# SITE PLAN APPROVAL - Grandview North

PROJECT INFORMATION									
<b>Project Title</b>	Grandview North			<b>Date of Report</b>	May 13, 2020				
<b>File Number</b>	PA19037			<b>Attachments</b>	Preliminary Site Plan (Exhibit 50); MDNS (Exhibit 43)				
<b>Administrative Recommendation</b>	Approve the preliminary Multi-family Site Plan subject to the conditions of approval contained in Section 2.0 of this Administrative Site Plan Approval.								
BACKGROUND SUMMARY									
<b>Applicant</b>	Grandview North LLC								
<b>Request</b>	The applicant is requesting Administrative Multi-family Site Plan Approval in order to construct a 116 unit apartment complex within three separate buildings, including parking, open space, landscaping and critical area buffer enhancement on a 4.78-acre site.								
<b>SEPA Status</b>	A Mitigated SEPA Threshold Determination of Non-Significance was issued on March 5, 2020. No appeals were filed.								
<b>Site Location</b>	West side of 51 <sup>st</sup> Avenue NE between the 14400 - 14600 Block			<b>APN(s)</b>	31053300401100

**GRANDVIEW NORTH, LLC**  
REMINOTON PLACE  
**SITE PLAN**  
CITY OF MARYSVILLE  
PA 19-037  
1 OF 1  
# 21663

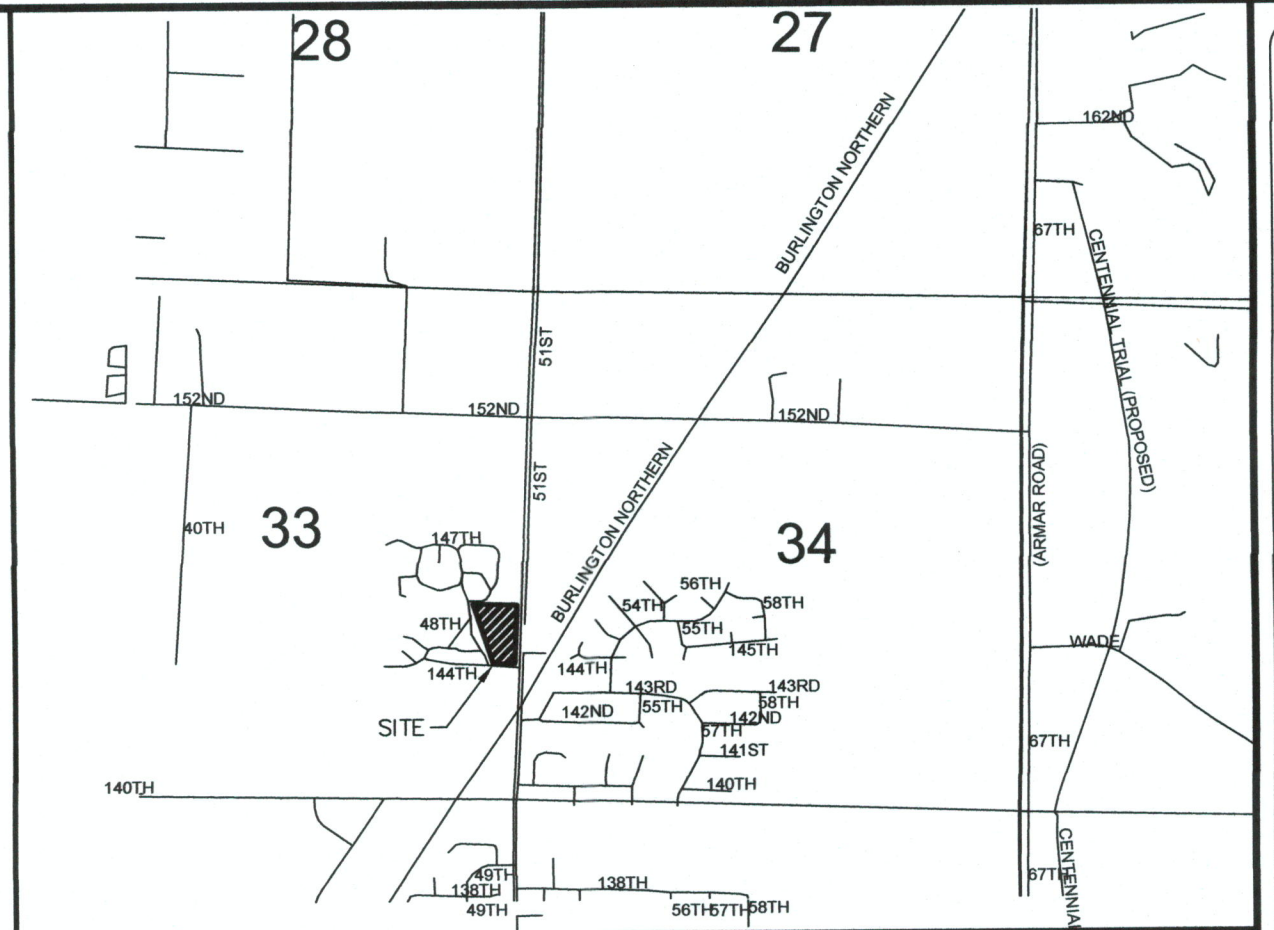
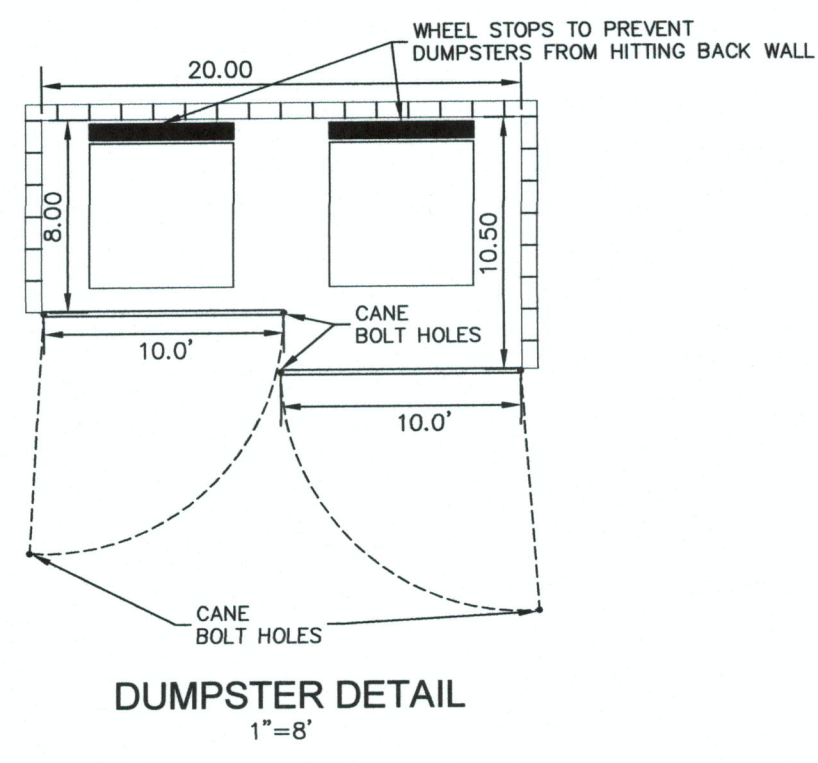
3. As noted on the face of the preliminary site plan, the applicant shall demonstrate compliance with the following design elements outlined in the MMC:

- a. Prior to preliminary site plan approval, the applicant shall be required to demonstrate compliance with MMC 22C.010.290(2), *Relationship of Buildings to Site and Street Front*.

- b. Prior to civil construction plan approval, the applicant shall have a *FINAL* landscaping plan approved that includes all of the plan submittal requirements outlined in MMC 22C.120.030, and includes all of the applicable design elements outlined in MMC 22C.010.290(4), *Landscaping and Site Treatment* and MMC Chapter 22C.120.

- c. Prior to civil construction plan approval, an exterior lighting plan shall be provided in accordance with MMC 22C.010.290(4)(c) and MMC 22C.130.050(3)(d).

- d. Prior to civil construction plan approval, the applicant shall be required to demonstrate compliance with MMC 22C.010.290(5), *Site Design Utilizing Crime Prevention through Environmental Design (CPTED) Principles*.

- a. PRIOR TO PRELIMINARY SITE PLAN APPROVAL, THE APPLICANT SHALL BE REQUIRED TO DEMONSTRATE COMPLIANCE WITH MMC 22C.010.290(2) RELATIONSHIP OF BUILDINGS TO SITE AND STREET FRONT.

- b. PRIOR TO CIVIL CONSTRUCTION PLAN APPROVAL, THE APPLICANT SHALL HAVE A FINAL LANDSCAPING PLAN APPROVED THAT INCLUDES ALL OF THE PLAN SUBMITTAL REQUIREMENTS OUTLINED IN MMC 22C.120.030, AND INCLUDES ALL OF THE APPLICABLE DESIGN ELEMENTS OUTLINED IN MMC 22C.010.290(4) LANDSCAPING AND SITE TREATMENT AND MMC CHAMPTER 22C.120.

- c. PRIOR TO CIVIL CONSTRUCTION PLAN APPROVAL, AN EXTERIOR LIGHTING PLAN SHALL BE PROVIDED IN ACCORDANCE WITH MMC 22C.010.290(4)(c) AND MMC 22C.130.050(3)(g).

- d. PRIOR TO PRELIMINARY SITE PLAN APPROVAL, THE APPLICANT SHALL BE REQUIRED TO DEMONSTRATE COMPLIANCE WITH MMC 22C.010.290(5) SITE DESIGN UTILIZING CRIME PREVENTION THROUGH ENVIRONMENTAL DESIGN (CPTED) PRINCIPLES.
